US Forest Service Aviation Safety Alert

No. FS 09-02

July 31, 2009

Subject: Rappel Equipment and Procedural Change
Area of Concern: Rappel Operations
Distribution: Rappel Bases

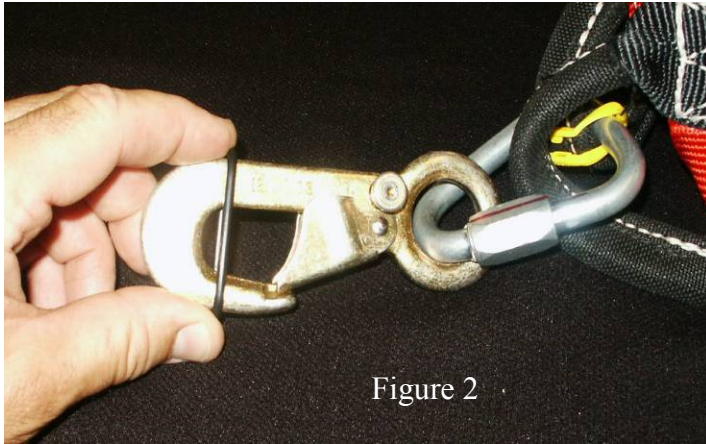
After the locking nut is tightened, a contrasting color of fingernail polish shall be used to apply a longitudinal witness mark on the uppermost facet of the locking nut extending $\frac{1}{2}$ inch onto the tri-link (red line on tri-link in Figure 1). The witness mark will permit a rappeller or rappel spotter to confirm through visual inspection that the locking nut is secure and has not rotated since it was tightened.

Figure 2

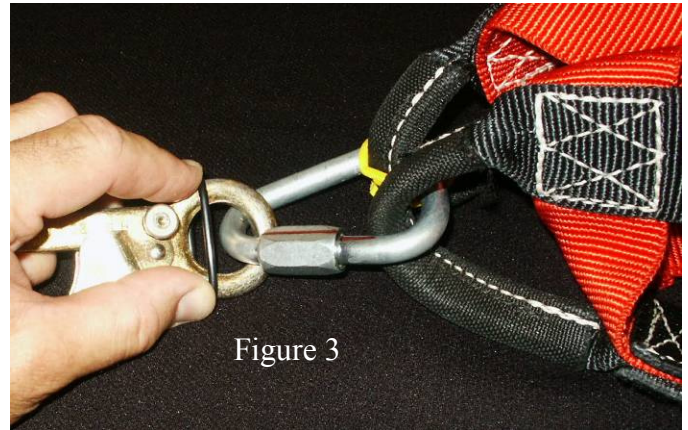
To install an apex O-ring, slip the O-ring over the tip of the snap hook (Figure 2), and slide the O-ring down the snap hook (Figure 3) and over the eye until the O-ring contacts the tri-link (Figures 4,5). Any qualified rappeller can replace a snap hook O-ring as long as they do not open the tri-link during the process.
